**VERMONT AGENCY OF TRANSPORTATION**

PROJECT NAME: BENNINGTON  
 PROJECT NUMBER: AC NH 019-1(52)  
 FILE NAME: ...plot.files\zd307c2p02.pff  
 DESIGN SUPERVISOR: GREG EDWARDS  
 DESIGNED BY: MARC FOISY  
 GENERAL PLAN P-02  
 PLOT DATE: 5/16/2011  
 DRAWN BY: STANTEC  
 CHECKED BY: GARY SANTY  
 SHEET 72 OF 267

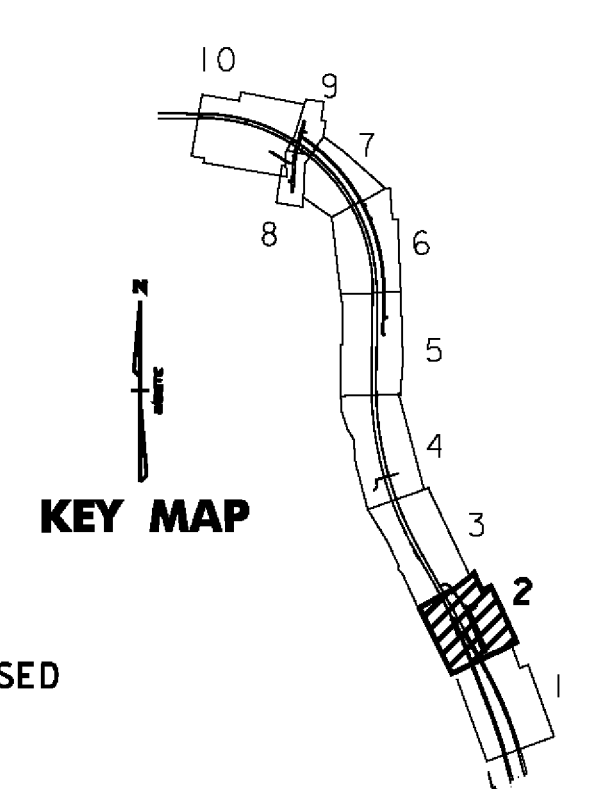
- ~~JUNCTION BOX NOT USED~~
- ~~STA. NB 6+569.772, 19.5m LT.~~
- ~~STA. NB 6+569.871, 4.7m LT.~~
- 6+502.42m RT WOVEN WIRE FENCE WITH STEEL POSTS 6m RT

- BARRIER FENCE**
- STA. NB 6+645.685, 60.0m LT. - STA. NB 6+715.587, 30.5m LT.
- ~~NOT USED ADDED TO CONTRACT 51~~
- ~~ELECTRICAL CONDUIT SLEEVE (200 MM) (PVC) (SCH 80)~~

- ~~STA. NB 6+569.601, 4.2m LT.~~
- ~~STA. NB 6+570.291, 19.8m LT.~~
- ~~STA. NB 6+569.871, 4.7m LT.~~
- ~~STA. NB 6+576.443, 4.7m LT.~~
- REMOVAL OF EXISTING FENCE**

- STA. VB 1+092.844, 14.9m RT. - STA. VB 1+100.366, 12.3m LT.
- STEEL BEAM GUARDRAIL**
- ~~CEGAR LOG RAIL NOT USED~~
- STA. CV 5+130.745, 2.000m LT. - STA. VR 1+120.000, 2.000m LT.

- SPECIAL PROVISION (DECOMMISSION OBSERVATION WELL)**
- STA. NB 6+649.000, 47.0 m RT. (B-25)
- STA. NB 6+672.000, 19.0 m RT. (B-26) NOT DONE
